Treatment and Disposal of Waterworks Sludge from Existing Water Treatment Works

Environmental Impact Assessment Final Assessment Report

October 1995

Final Assessment Report

Figure 7.3 : Water Treatment Processes and Proposed Works at Tsuen Wan WTW

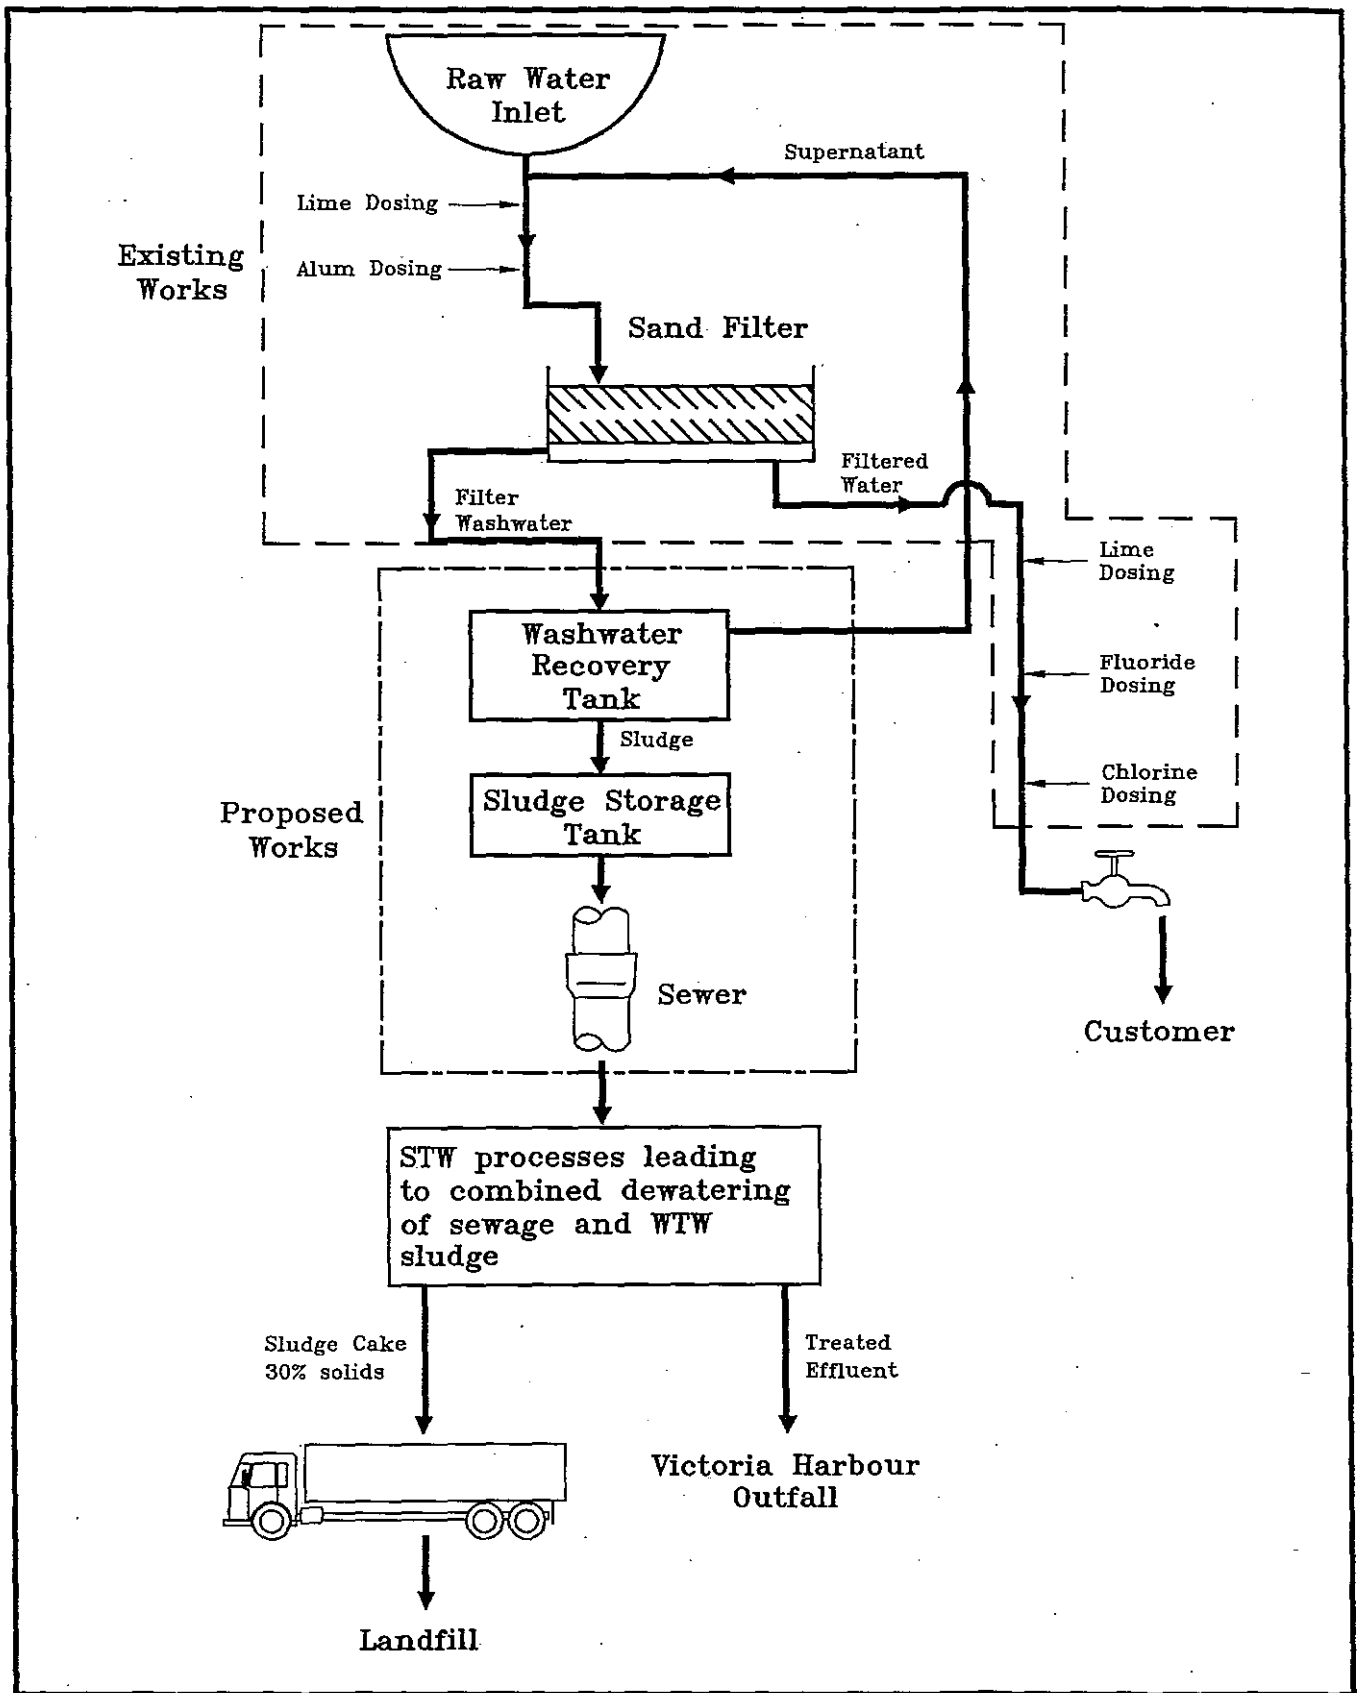
7.2.2	The latest scheme is to provide five washwater recovery tanks. Relevant text and diagram should be amended.	Agreed.
Fig 7.3	The dosing of lime, fluoride and chlorine should be shown as part of the existing works. "Raw Water Reservoir" is suggested to read "Raw Water Inlet".	Agreed.

8.1.6	A trunk main will be laid from Shek Lei Pui T/W to Kau Wah Keng No.1 and No.2 S/Rs along Cheung Yuen Road. Construction will take approximately 1 year commencing later this year.	Agreed.
Fig 7.3	Same comment as on Figure 7.3	Agreed.

Figure 8.2a : Layout of Proposed Sludge Pipeline at Shek Lei Pui WTW

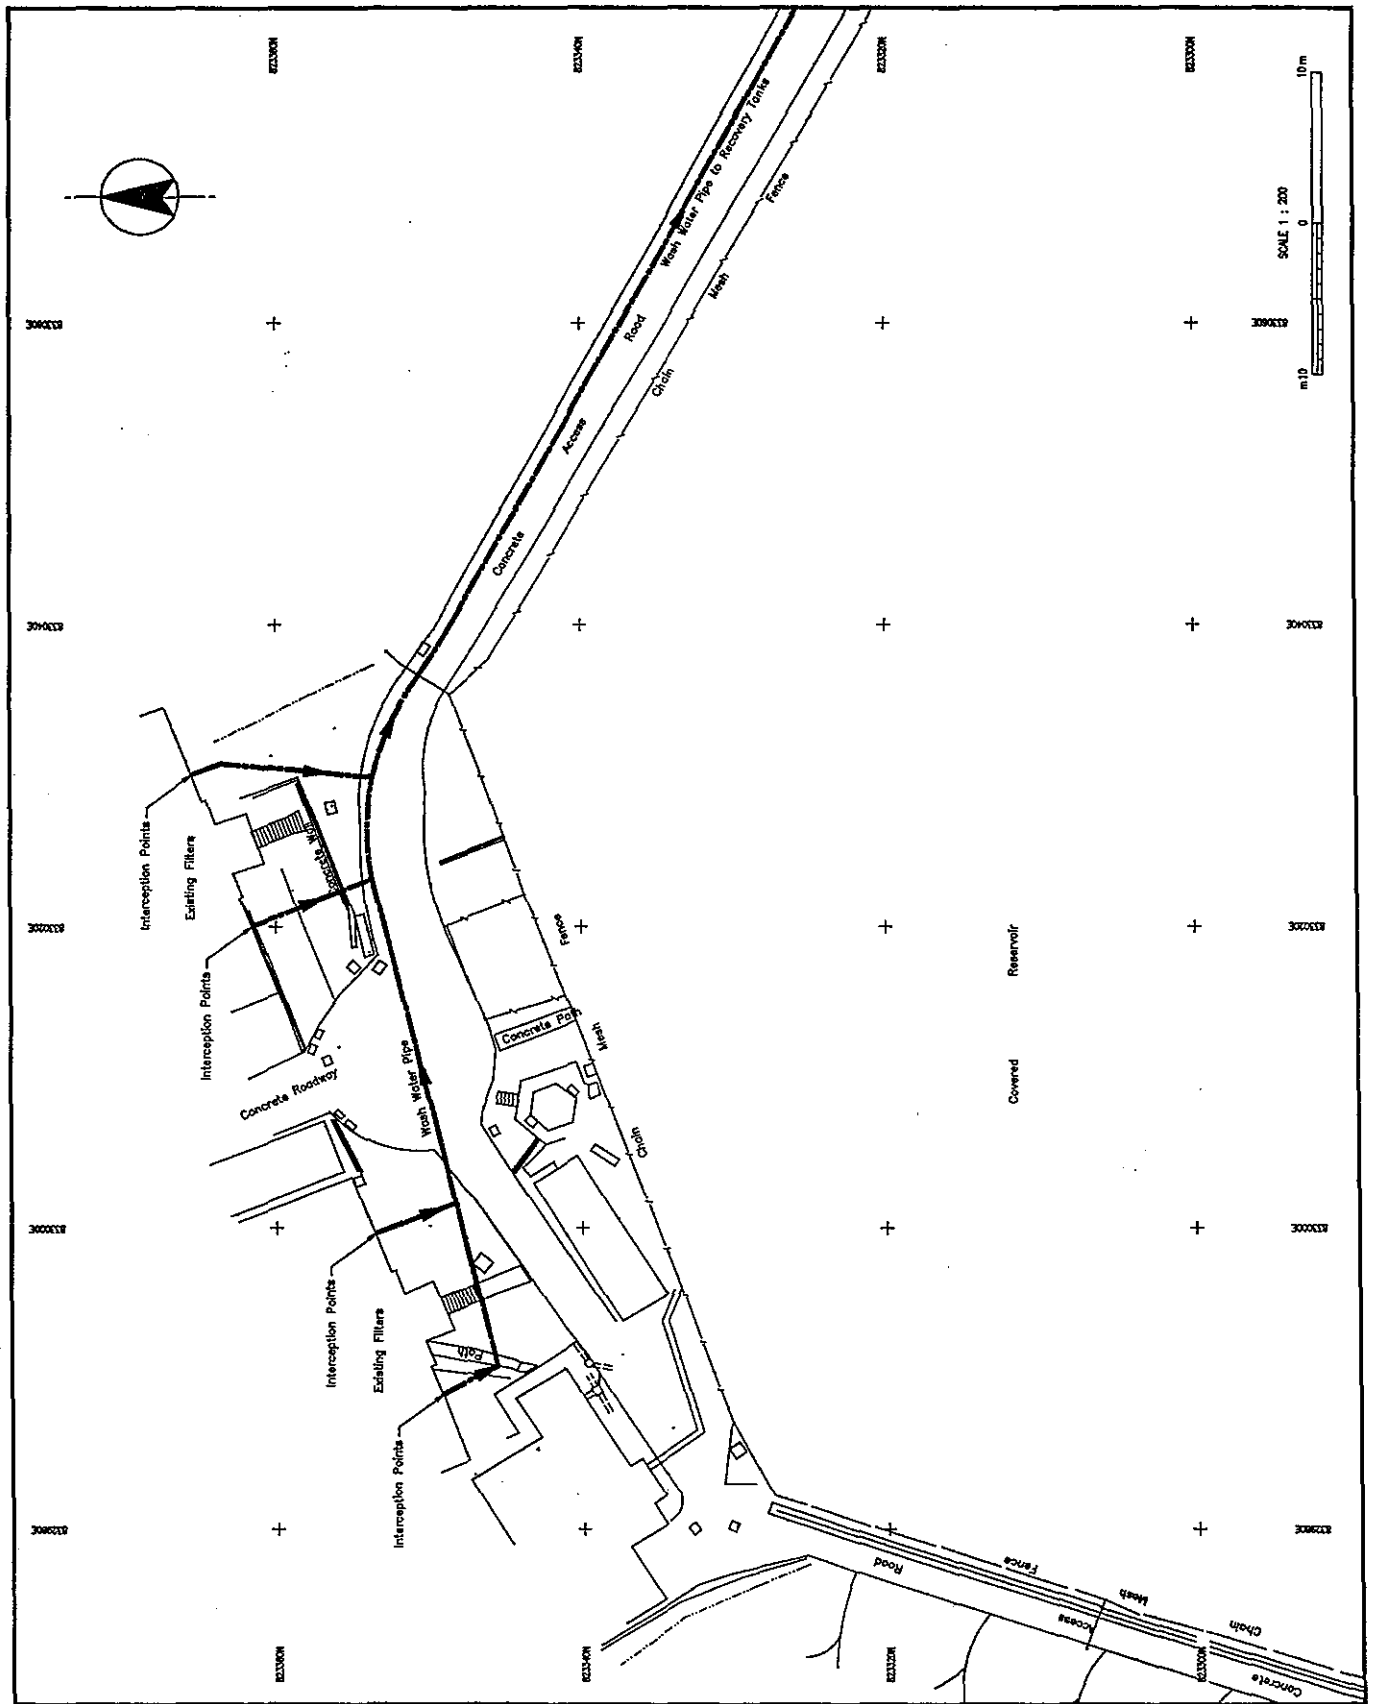
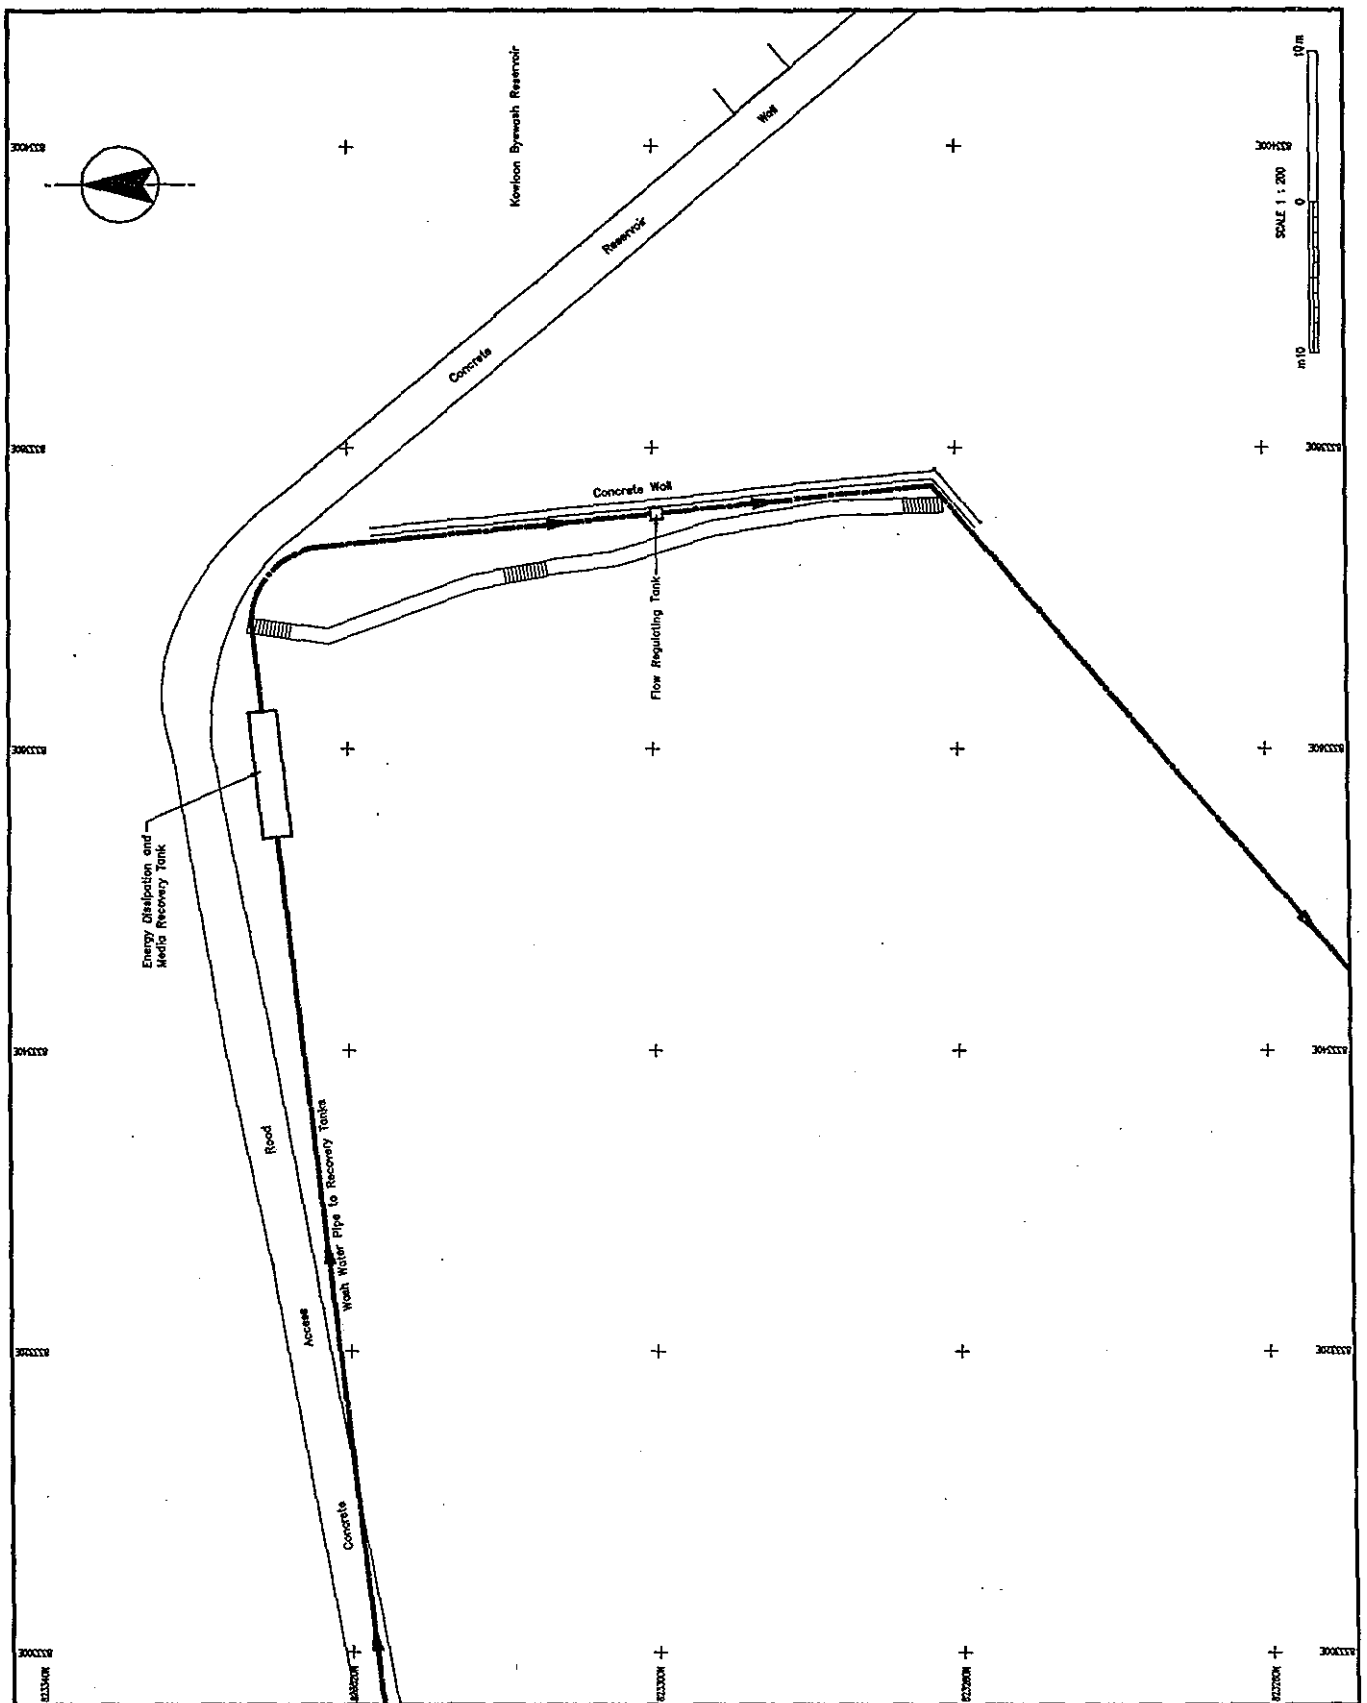
4. Section 8 - Shek Lei Pui WTW
- (a) The Consultant should provide a full drawing of Figure 8.2 covering all the details of the proposal up to the thickening facilities at Tai Po Road WTW including the media recovery tank and the flow regulating control chamber near the Kowloon Byewash Reservoir Dam. The supernatant return pipe/flow from Tai Po Road WTW should also be shown in this Figure and Figure 8.3 if the return is agreed. Figure 8.2 will be extended (or further Figures inserted) to show the entire route to Tai Po Road WTW, including the media recovery tank and flow regulating chamber. We have not been instructed to install a return supernatant pipe.

Figure 9.1
Proposed Development and Nearest Sensitive Receiver Location-Tai Po Road WTW

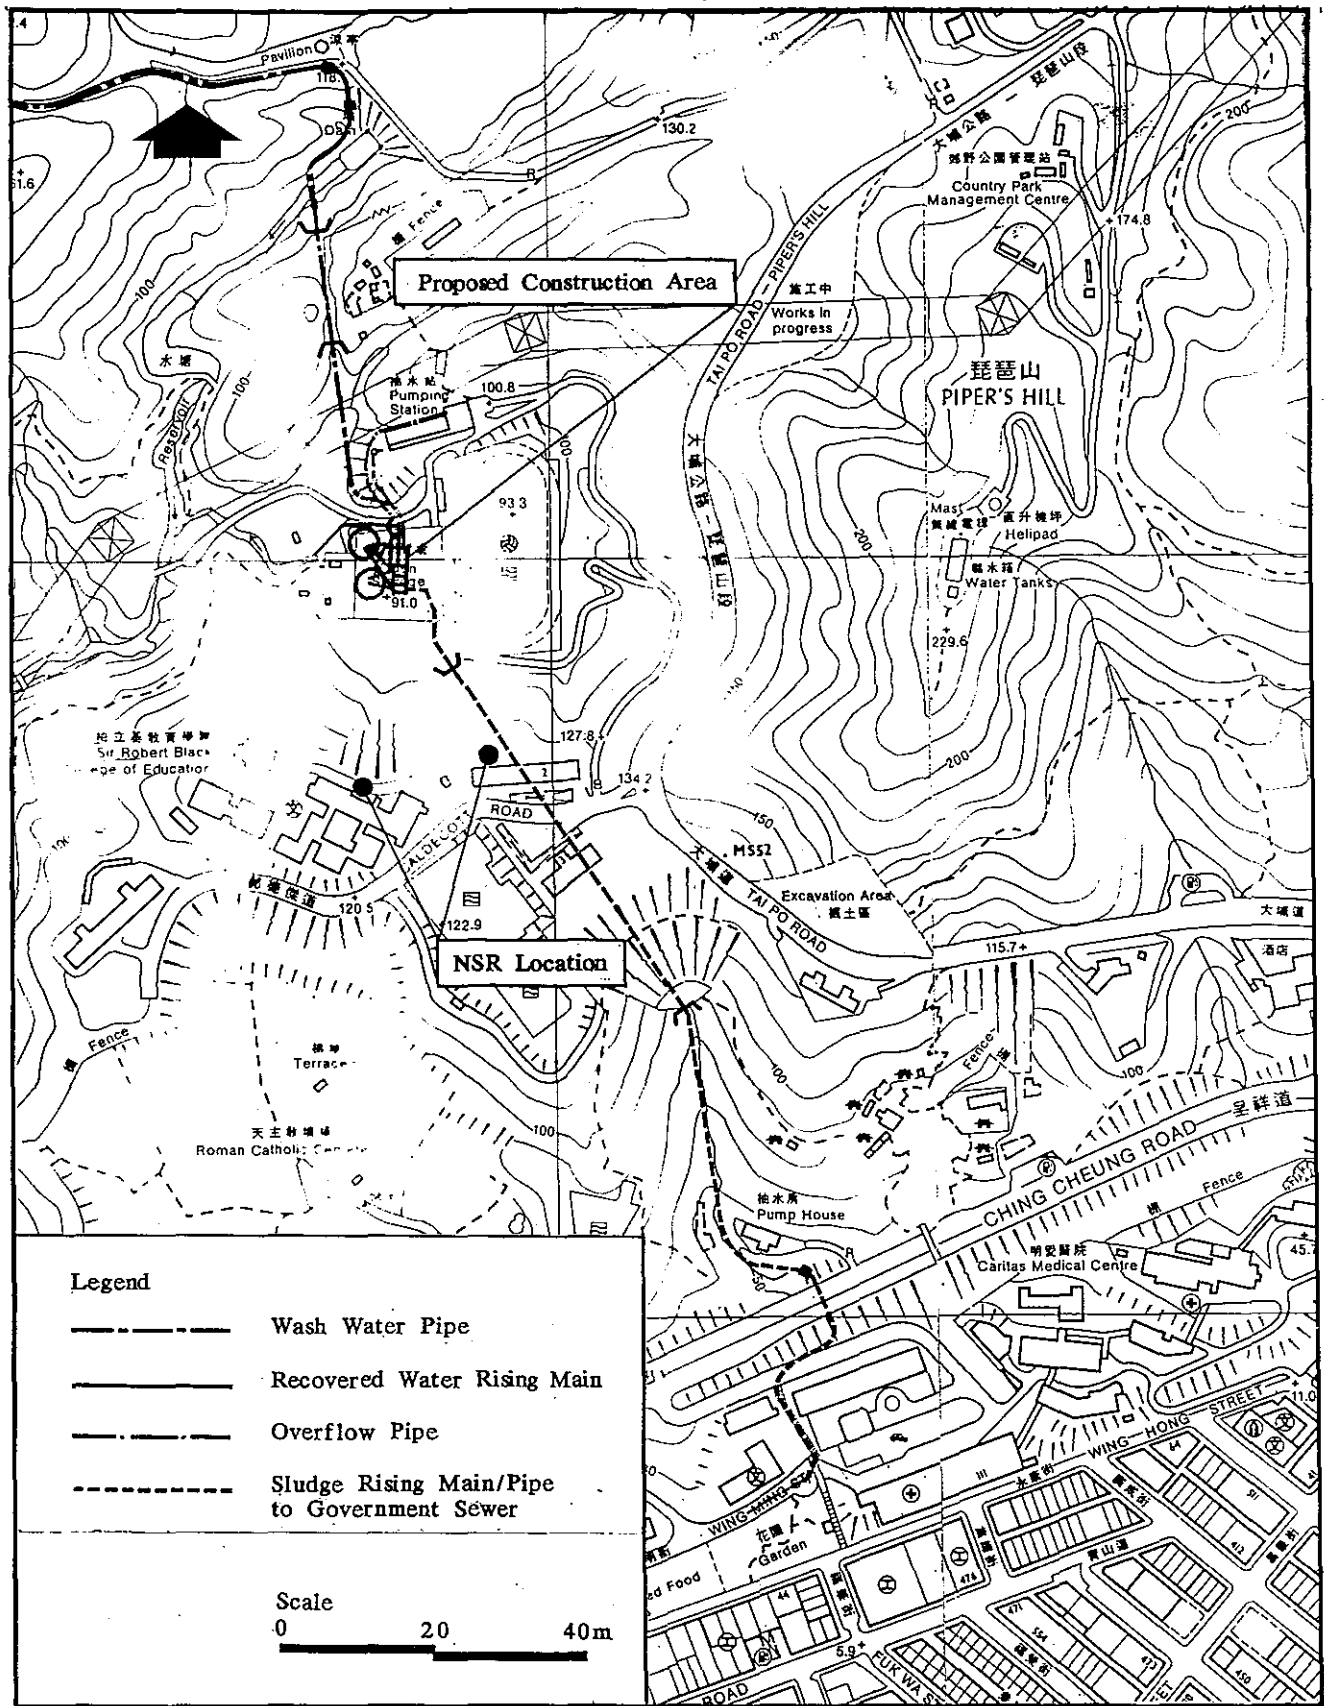
<p>Tai Po Road (d) The proposed development limits to works within the existing WTW boundary and a 300 mm pipeline connecting to Wing Ming Street. As the pipeline has not been clearly annotate in Figure 9.1, I presume that it is the one shown in Figure 8.1 running across Caldecott Road, Ching Cheung Road and Wing Ming Street. The busy traffic on Ching Cheung Road would be a major constraint to the laying of the pipeline and para 9.2.3 may thus need to address related problems. In connection with the pipework at the said roads, which fall in Kowloon Region, CHE/K should be consulted.</p>	<p>The pipe route will be added to Figure 9.1. The report will address the issues following the resolution that the pipeline will not now be entrusted to others. Trenchless pipelaying techniques will be used.</p>
<p>Tuen Mun and Silvermine Bay (d) As the proposed development lies within the existing WTW boundary only, I have no comment.</p>	<p>CHE/K will be consulted in connection with work on Wing Ming Street</p>
